Response to the Independent Science Advisory Panel Workshop No. 2 Report

Question 1: What are the Panel's suggestions on the MBR testing progress, including microbiological method development and preliminary microbiological and pretesting performance results?

Figure 1. Ten years of Sanitation Districts lab total organic nitrogen data from secondary effluent composite samples

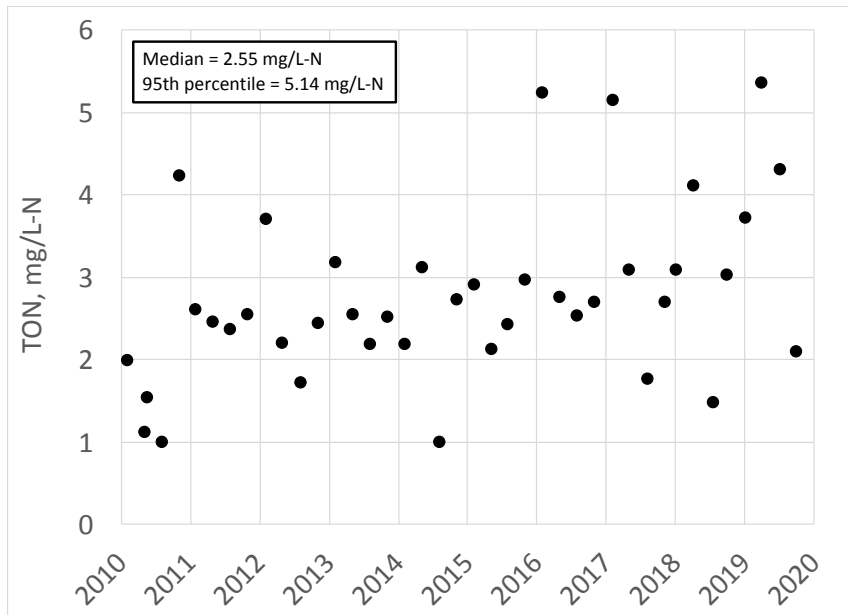
At Workshop No. 2, the influent organic N concentrations were reported for grab samples collected and analyzed using the Hach Simplified TKN Method. The panel indicated that the relatively high level of organic N observed in the influent could reflect industrial sources of organic nitrogen, which can inhibit nitrification and/or denitrification. The project team investigated this topic by reviewing JWPCP's historical effluent data and the analytical procedure for any potential issues.

Figure 1 below presents the past 10 years of total organic nitrogen (TON) in composite samples of

disinfected JWPCP secondary effluent analyzed for compliance. The median TON concentration was 2.55 mg/L-N while the 95th percentile value was 5.15 mg/L-N. It is important to note that these data represent the TON (not dissolved organic nitrogen (DON)) in the JWPCP secondary effluent. Using this information and typical secondary effluent TSS data, the dissolved organic nitrogen (DON) level was estimated at approximately 1.5 mg/L-N. This DON level is similar to levels reported by other plants (USEPA, 2010). As such, at least based on historical data, JWPCP secondary effluent does not appear to contain elevated levels of recalcitrant organic nitrogen, in contrary to what was suggested during Workshop No 2.
